Provide Construction Services for Replacement of
Graceland Park/O'Donnell Heights Elementary/Middle School #240 and
Holabird Elementary/Middle School #229
Baltimore City Public Schools (City Schools)

ADDENDUM #6

**GRACELAND PARK/O'DONNELL HEIGHTS ELEMENTARY/MIDDLE SCHOOL NO. 240
BALTIMORE, MARYLAND
ADDENDUM #6**

**HOLABIRD ELEMENTARY/MIDDLE SCHOOL NO. 229
BALTIMORE, MARYLAND
ADDENDUM #6**

ADD 6
SK-A-6.2

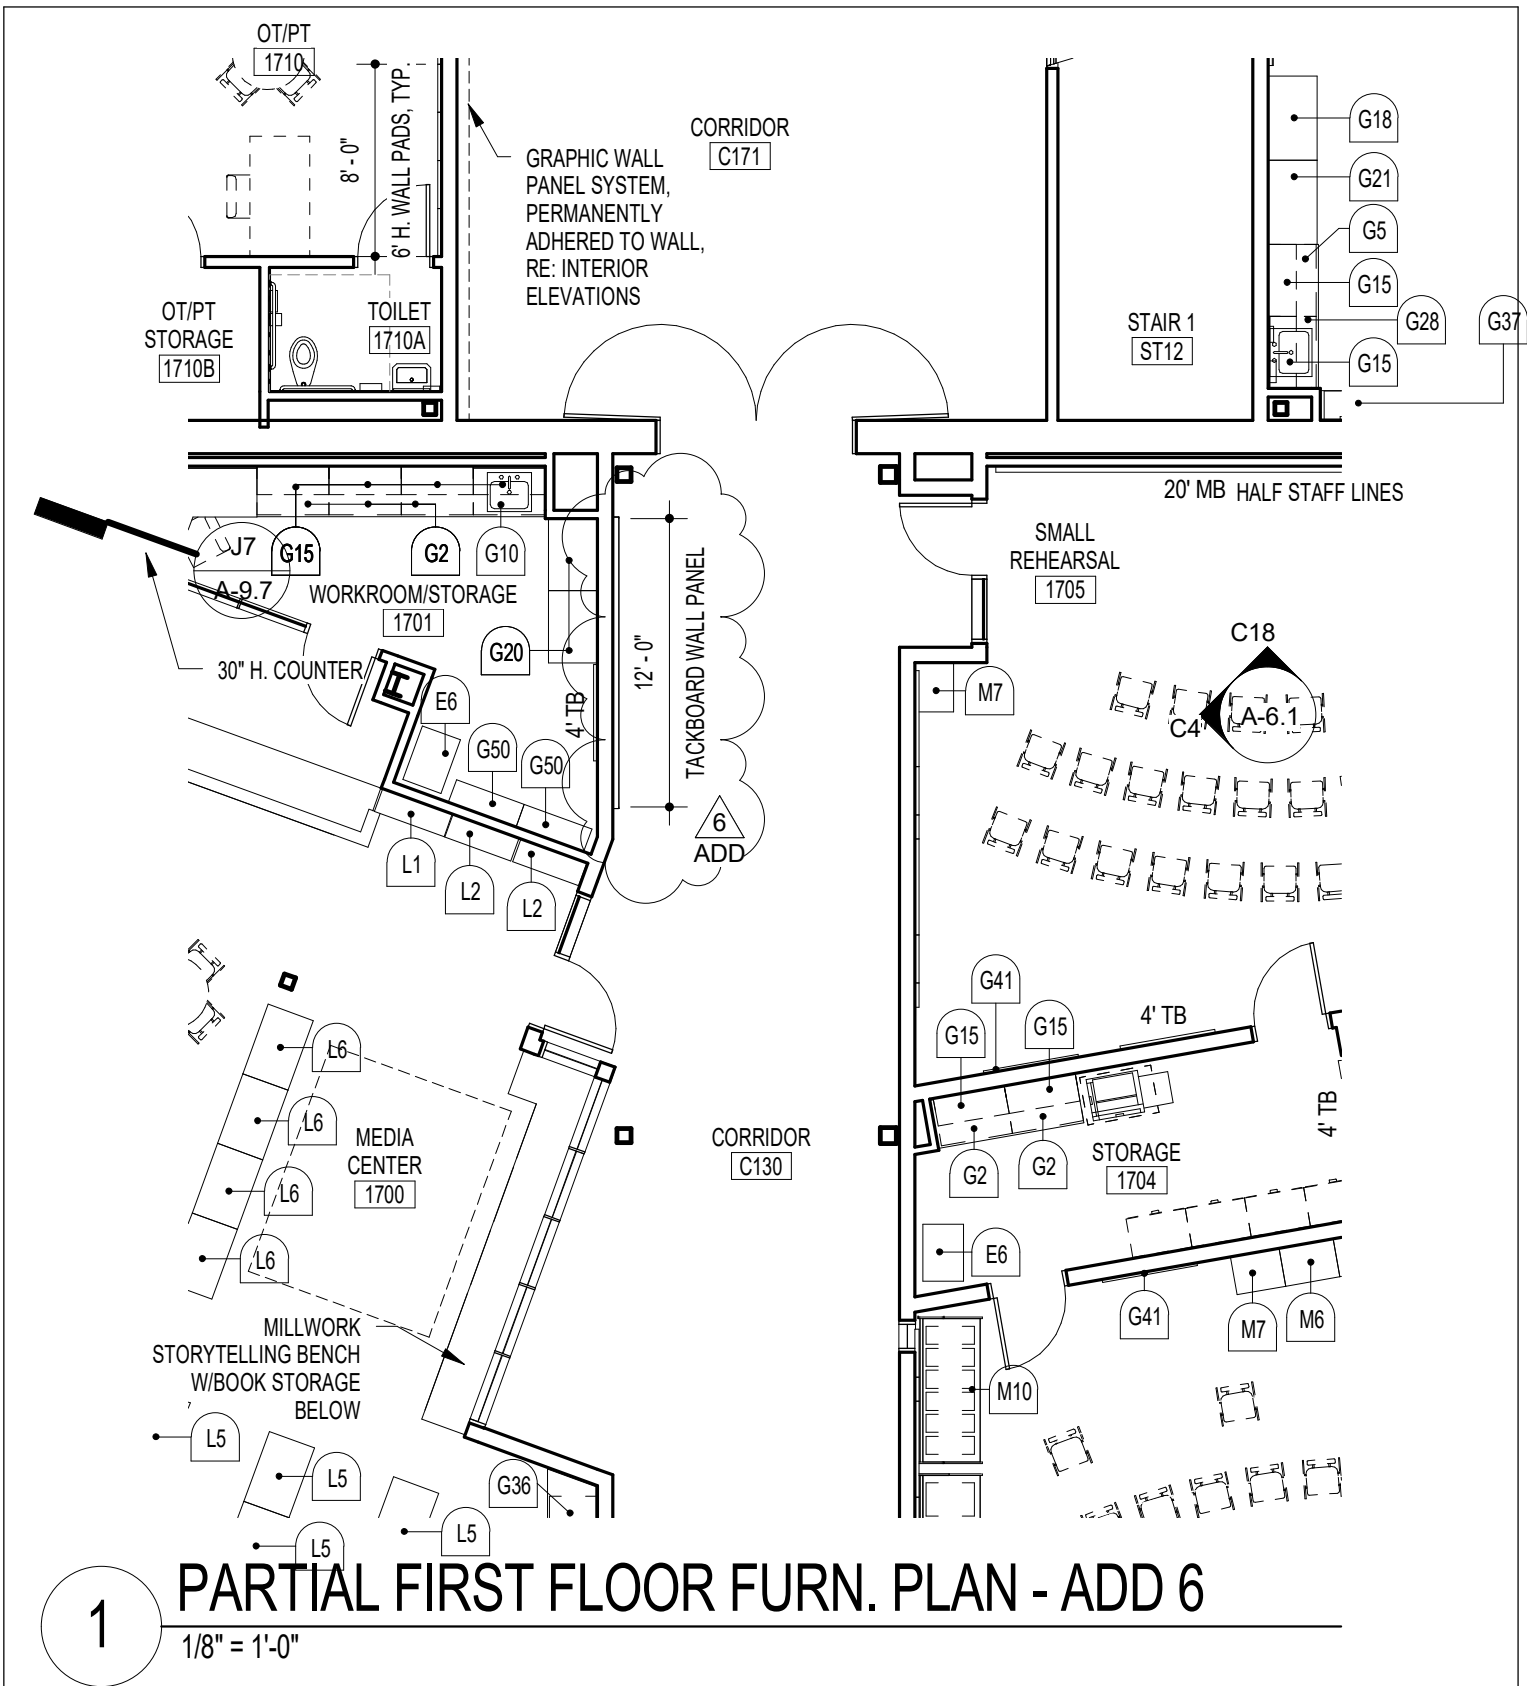
REVISE
REVISE | <u>SHEET A-9.2</u>
Tackboard Wall Panel annotation in Corridor C130 per Sketch SK-A-6.2
Tackboard Wall Panel annotation in Corridor C180 per Sketch SK-A-6.3 |

ADD 6
SK-A-6.3

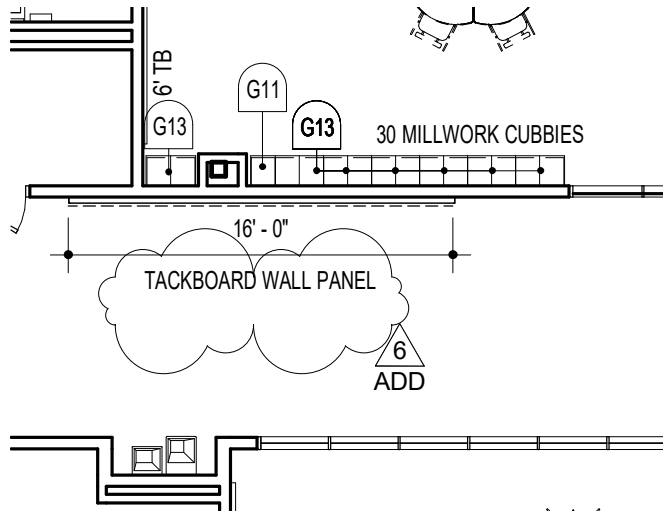
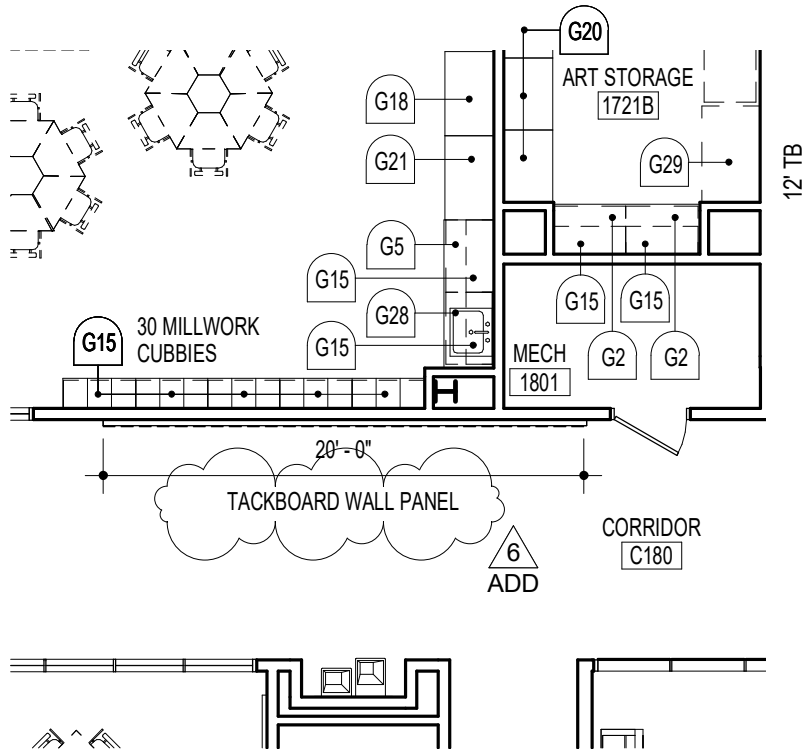
REVISE | <u>SHEET A-9.3</u>
Tackboard Wall Panel annotation in Corridor C190 per Sketch SK-A-6.3 |

ADD 6
 SK-A-6.4

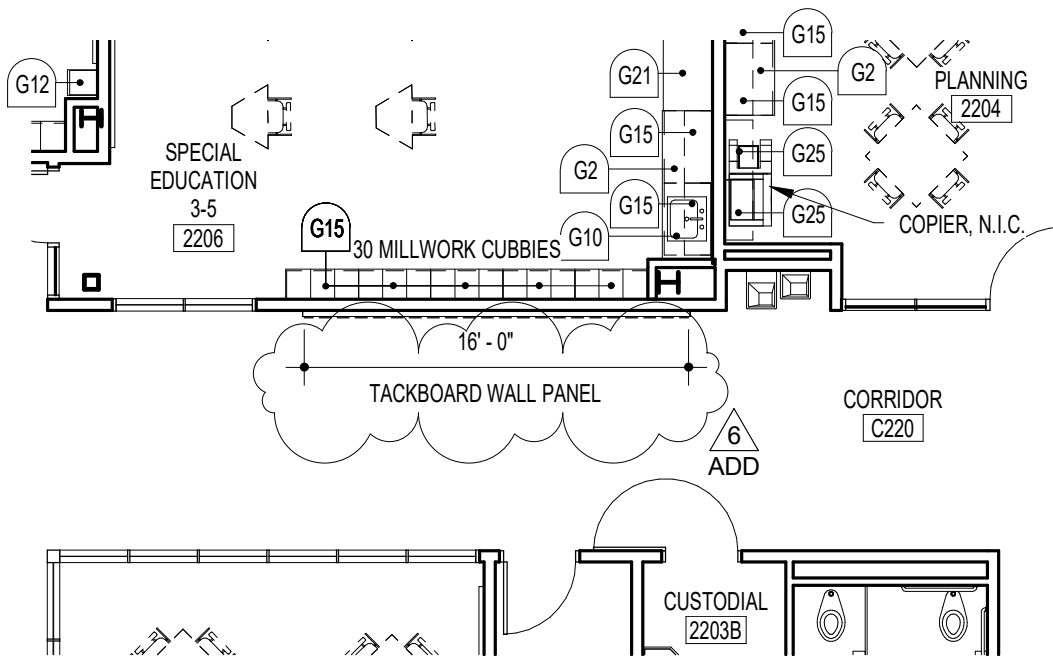
REVISE | <u>SHEET A-9.4</u>
Tackboard Wall Panel annotation in Corridor C220 per Sketch SK-A-6.4 |

SK-A-6.5

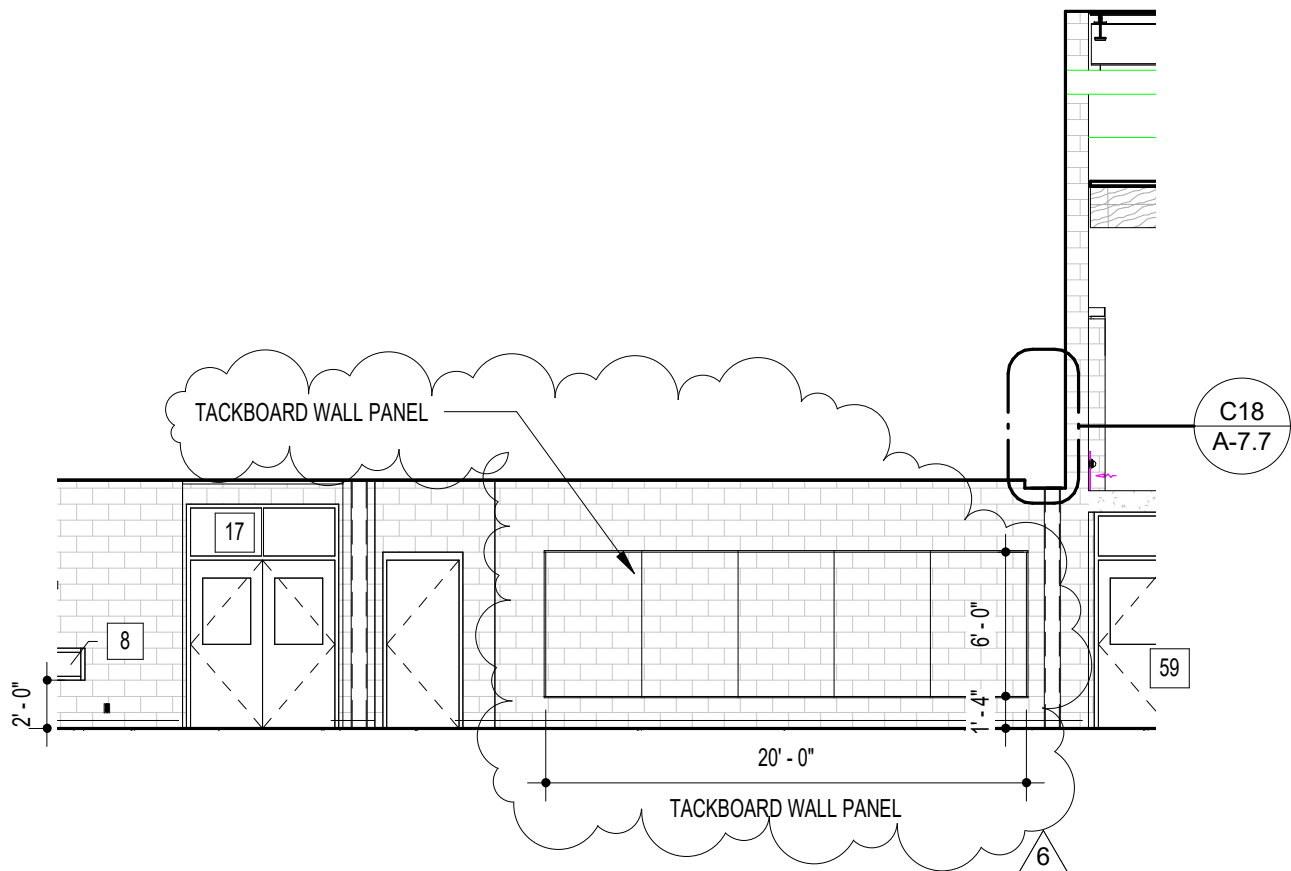
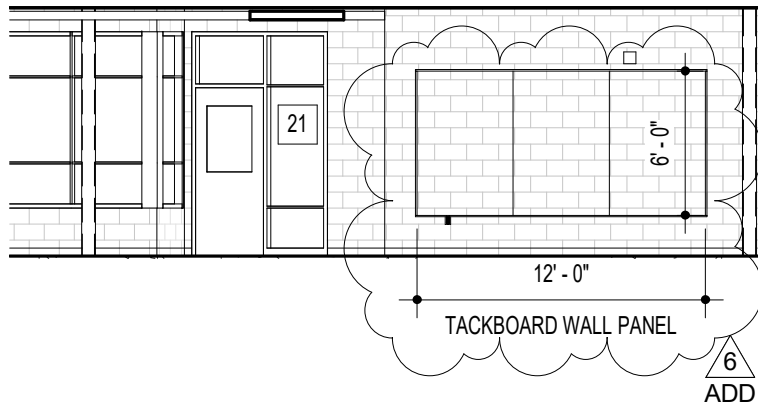
Please advise/give details for the “millwork art display wall” found on elevation D18/A-6.3, and the “millwork wall displays” found on plans at Corridors C130, C180, C190, and C220.

REVISE
REVISE | <u>SHEET A-6.3</u>
Tackboard Wall Panel annotation in Corridor C130 per Sketch SK-A-6.5
Tackboard Wall Panel annotation in Corridor C180, 190, and 220 per Sketch SK-A-6.6 |

These 5 items have been renamed in the plan and interior elevation drawings to “Tackboard Wall Panel”. Provide PINnacle N.C.F.R. tackboard by Homosote. Refer to specifications and drawings added in this Addendum.
